**FINAL DRAINAGE REPORT
FOR
FOUNTAIN VALLEY SALVATION ARMY
208 CUNNINGHAM DRIVE
COLORADO SPRINGS, CO 80911**

June 2, 2022
Revised: August 27, 2024

PCD Filing No.: CRD242

4.1 TYPES OF FILTRATION AND INFILTRATION SYSTEMS

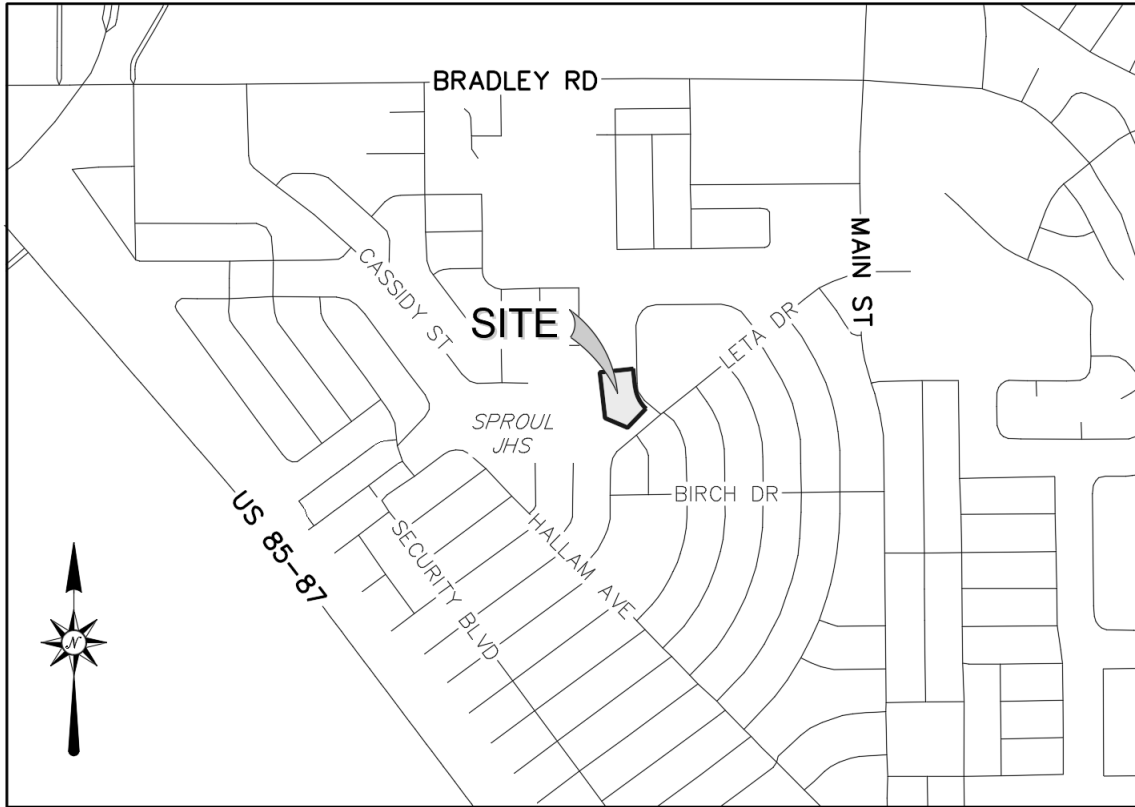
The below text from Section 4.0 of Chapter 4 starting on page 91 of 158 of MHFD's DCMv3, March 2024 edition, is provided for reference. Consider adding some of this guidance info into the drainage report text and/or GEC Plan notes.

Note that knowing the depth to groundwater is very important for a full infiltration system. So please discuss groundwater in the drainage report text.
